ADDENDUM NO. 1
TO THE
DRAWINGS AND SPECIFICATIONS
FOR THE
South College Mall Road Repaving Project

Issued From: The City of Bloomington
Planning and Transportation Department
Post Office Box 100
401 North Morton Street, Suite #130
Bloomington, Indiana 47402

Issue Date: July 29th, 2020

INDIANA DEPARTMENT OF TRANSPORTATION	
PEDESTRIAN PUSHBUTTON ASSEMBLY DETAILS	
SEPTEMBER 2017	
STANDARD DRAWING NO. E 805-PPBA-01	
	<i>/s/ David H. Boruff</i> DESIGN STANDARDS ENGINEER DATE <u>10/26/16</u>
	<i>/s/ Mark A. Miller</i> CHIEF ENGINEER DATE <u>11/01/16</u>

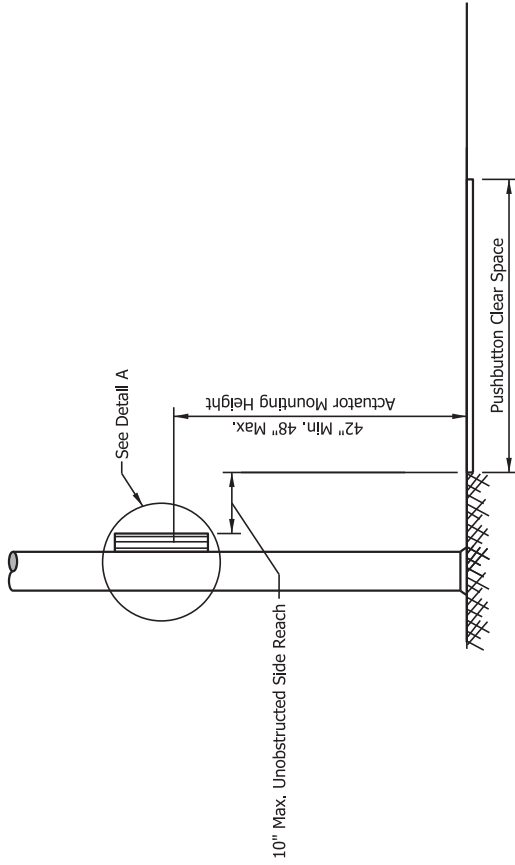
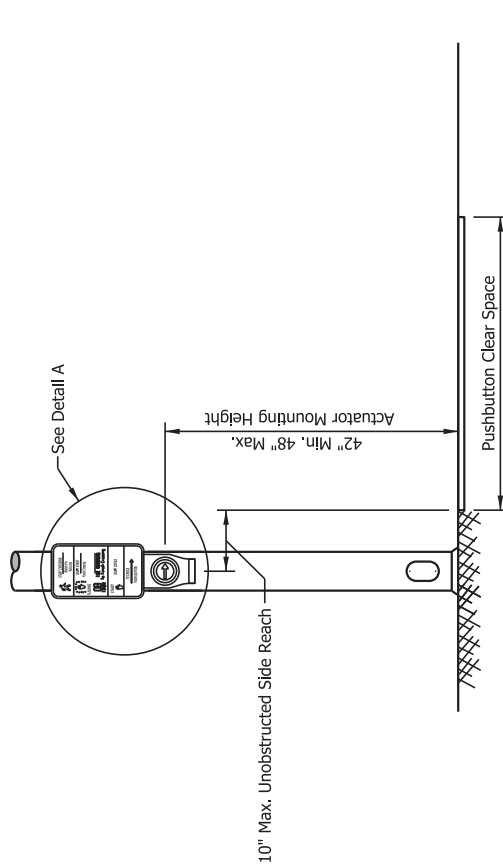
(Q) Please provide information, specification, etc on what is required for Item 31 Pedestrian Push Button, Retrofit.

(A) The item Pedestrian Push Button, Retrofit shall be used to adjust the locations of existing push buttons on existing poles in order to bring them into compliance with ADA and PROWAG guidelines. This work may include raising or lowering the existing buttons, or extending the button assembly out to meet minimum reach standards. Standard Specification Drawing E-805-PPBA-01 is being provided as a part of this addendum.
